A/C Inoperative - Rear A/C Line Retainer Missing

Service Category Vehicle Interior

Section Heating/Air Conditioning

Figure 1. Location of the A/C Line Retainers (Piping Clamps)

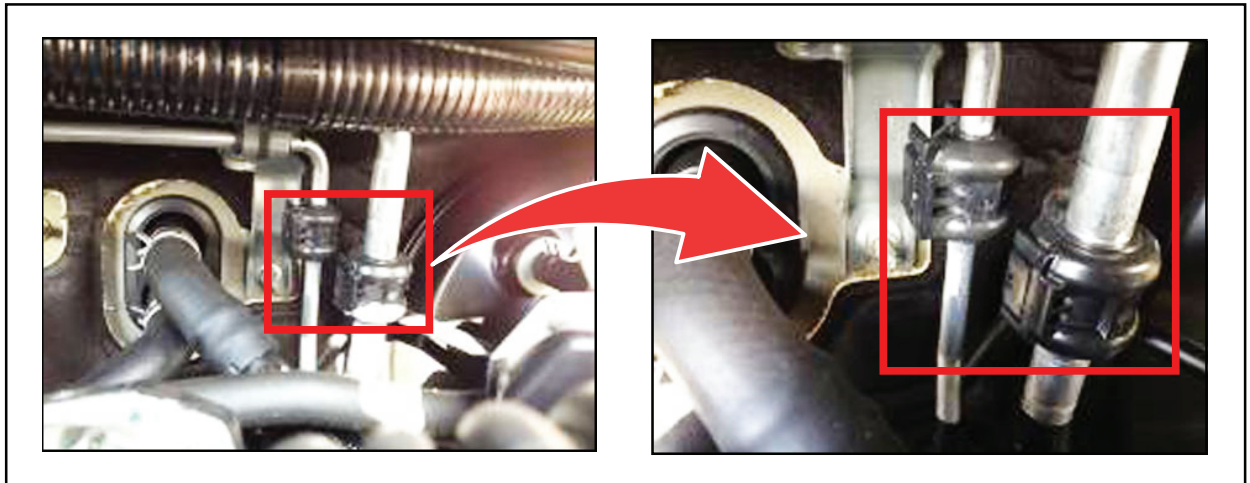
- If the A/C Line Retainer is intact and latched, this bulletin does NOT apply. Continue diagnosis using the applicable Repair Manual.
 - If one or both of the A/C Line Retainers is missing or unlatched, proceed to step 2.
2. Recover the refrigerant following the Repair Manual instructions.

3. If the A/C Line Retainer is still present but unlatched, remove it and replace it with a NEW A/C Line Retainer.
4. If the A/C Line Retainer is missing, then install the NEW A/C Line Retainer.
5. Once the NEW A/C Line Retainer is installed, recharge the refrigerant following the Repair Manual instructions.
 - [2011](#) / [2012](#) / [2013](#) Highlander:
Vehicle Interior – Heating/Air Conditioning – “Air Conditioning: Refrigerant: Replacement”
 - [2011](#) / [2012](#) / [2013](#) Sequoia:
Vehicle Interior – Heating/Air Conditioning – “Air Conditioning: Refrigerant: Replacement”
 - [2011](#) / [2012](#) / [2013](#) Sienna:
Vehicle Interior – Heating/Air Conditioning – “Air Conditioning: Refrigerant: Replacement”
6. Verify the A/C operates normally.
